**BELL BEND NUCLEAR POWER PLANT
RESPONSE TO RAI No. 79
BNP-2010-094 Docket No. 52-039**

Response to NRC Request for Additional Information No. 79
Questions 03.08.04-1, 2, 4, 5, 6, 13 subpart (a), 15, 16, 17, 19, 22 and 25
Bell Bend Nuclear Power Plant

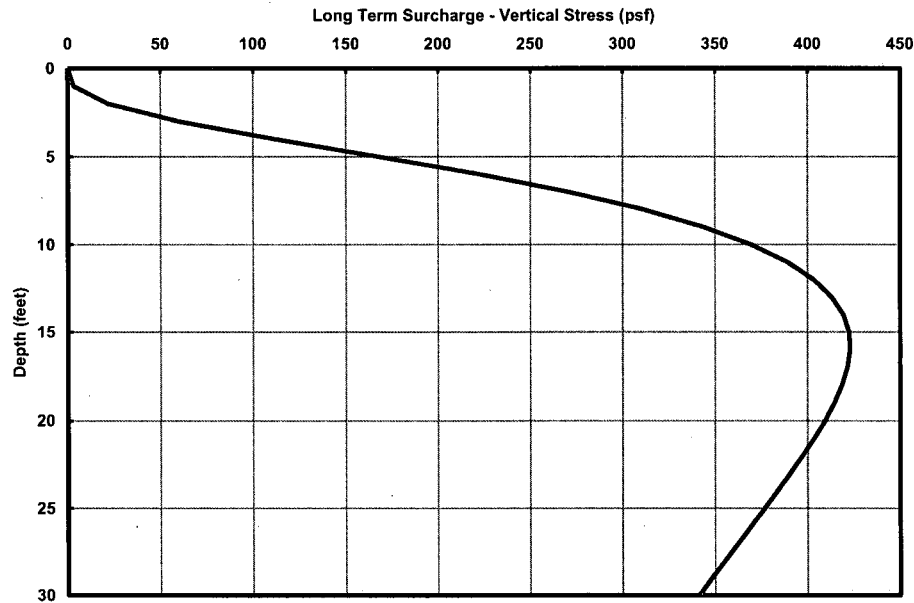
- (a) How is the apparent wave velocity determined when using the ASCE 4-98 equations to calculate the maximum axial strain and curvature? What wave impinging angle is assumed?
- (b) Described how the long-term surcharge loading is considered, including magnitude of these loads
- (c) Provide information that shows how the friction force is calculated /estimated in the axial strain calculation considering the slippage effect? What assumptions were made regarding the wave field, wave impinging angle, and apparent wavelength in the calculation/estimation for the friction force including the wave field, wave impinging angle, and apparent wavelength? Provide rationales for these assumptions.

(a2) Impinging Angle: ASCE 4-98 addresses impinging angle using the wave-velocity coefficients for different seismic waves (ASCE 4-98 Table 3.5-1). The wave-velocity coefficients maximize the axial strain and curvature by assuming the critical angle of incidence between the longitudinal axis of the buried utility and the seismic wave. An angle of 45 degrees produces the maximum axial strain due to shear-wave propagation and is factored into the wave-velocity coefficient of 2.0 presented in ASCE 4-98.

(b) Long Term Surcharge: Long term surcharge from shallow foundations adjacent to buried pipes is calculated using Boussinesq's method or Westergaard's method of stress distribution, and/or Slope Method. Applicable Poisson's ratios, which ranged from 0.35 to 0.40 per BBNPP FSAR Table 2.5-5, excluding the value for concrete fill, which is not used at BBNPP, are included in the Westergaard's equation. For example, given a 10 foot wide strip foundation at the ground surface, with a contact pressure of 2,000 pounds per square foot (psf), and the point for which the surcharge load is calculated being 5 feet outside the edge of the strip footing, long term surcharge is calculated based on the methodology in Poulos and Davis (1974), as illustrated below:

TYPICAL CONCRETE ENCASED
DUCT BANK CONSTRUCTION

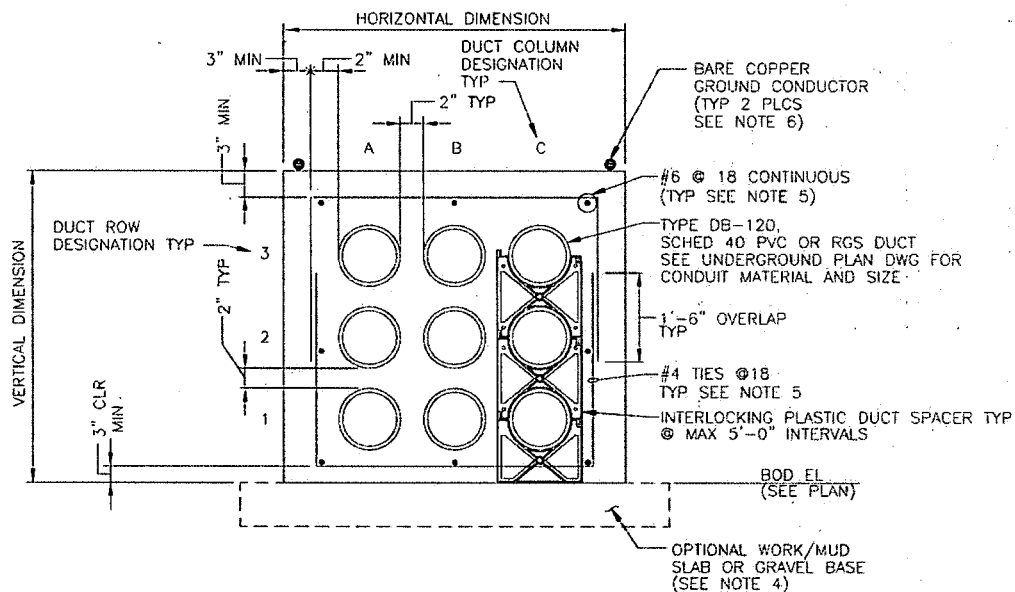
- (a) Is the cross section of the buried duct bank a rectangular shape?
- (b) Provide details describing the design of the concrete duct bank enclosures.

The material presented in BBNPP FSAR Section 3.7.3 did not discuss whether racking of the cross section due to the SSE was considered and how the design accommodates this racking. Provide a technical rationale for not considering this effect.

- (a) As shown in the PPL response NRC RAI 79, Question 03.08.04-3, in letter BNP-2010-085, dated March 19, 2010 (ML100830214), Item (a), the typical cross-section of the buried duct bank is a rectangular shape. The encasement cross section, including its reinforcement is shown below:
